Subject: AP1000 COL Standard Technical Report Submittal of APP-GW-GLN-106, (TR 106),
Revision 0

1. APP-GW-GLN-106, Revision 0, "AP1000 Licensing Design Changes for Mechanical System and Component Design Updates," Technical Report Number 106

Title: AP1000 Licensing Design Change Document for Generic Reactor Coolant Pump

2.0 Design Change Descriptions

Figure 1 CRDM Cooling Air Flow Path in IHP

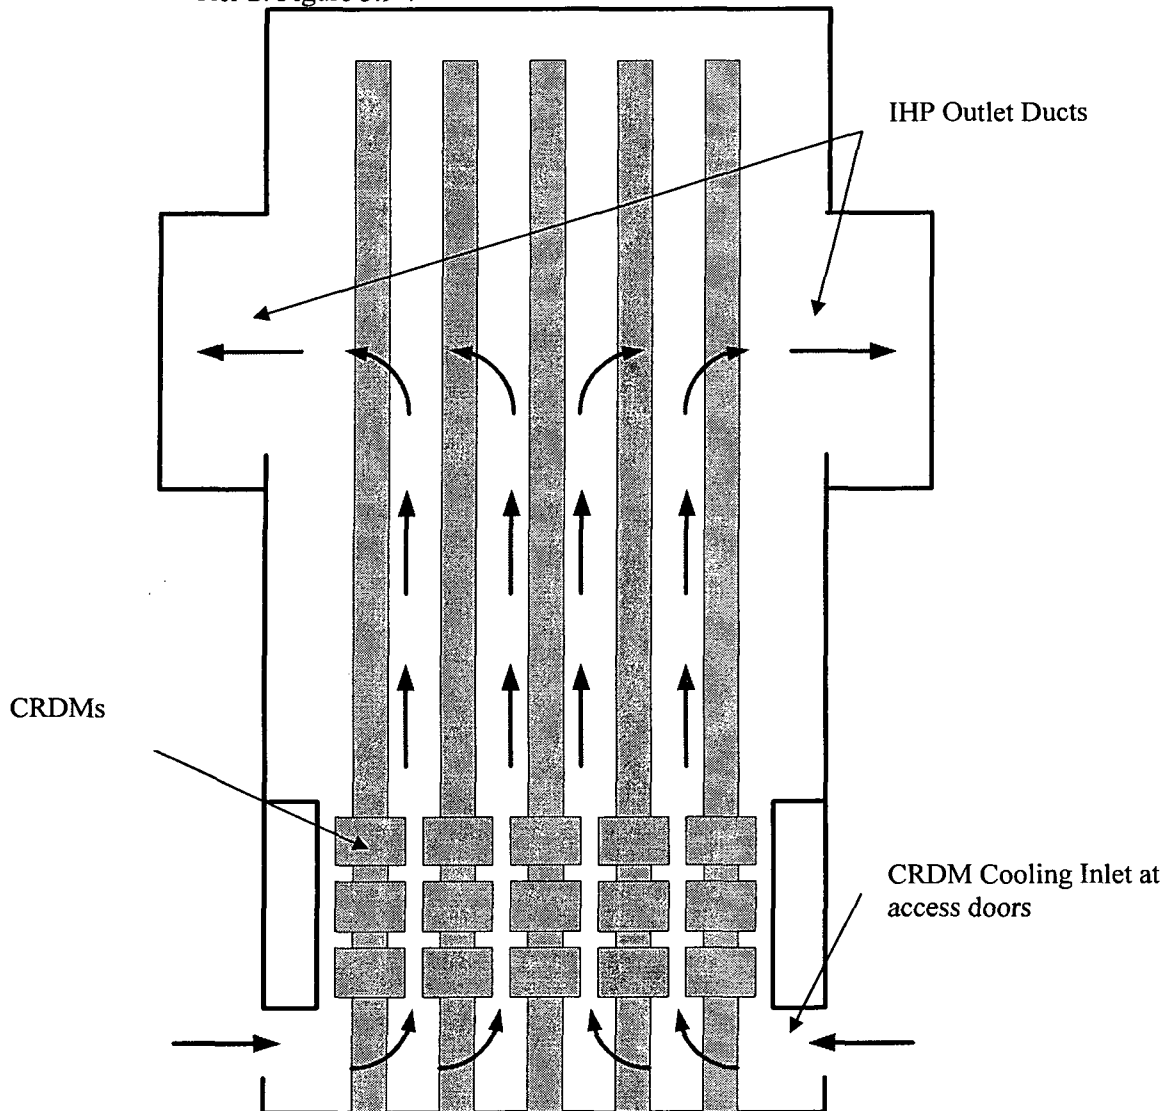
2.d Design Change 185, IHP Design:

One of the functions of the Integrated Head Package is to provide cooling to the CRDMs. A design change has been made to the CRDM cooling system to reduce the system pressure drop and CRDM air flow exit temperature. This has been achieved by removing the internal baffles that caused a high pressure drop. The CRDM airflow now is sucked in through the CRDM inspection doors, past the CRDMs and exits near the top of the IHP shroud. The airflow path is shown in the Figure 1 below. Figure 1 below supersedes the figure originally provided as part of the response to RAI TR61-01. TR 61 is Westinghouse document APP-GW-GLN-014, Revision 0 "AP1000 Integrated Head Package."

The IHP design change has resulted in updates to the following subsections of the DCD:

- Tier 2: Figure 3.9-7
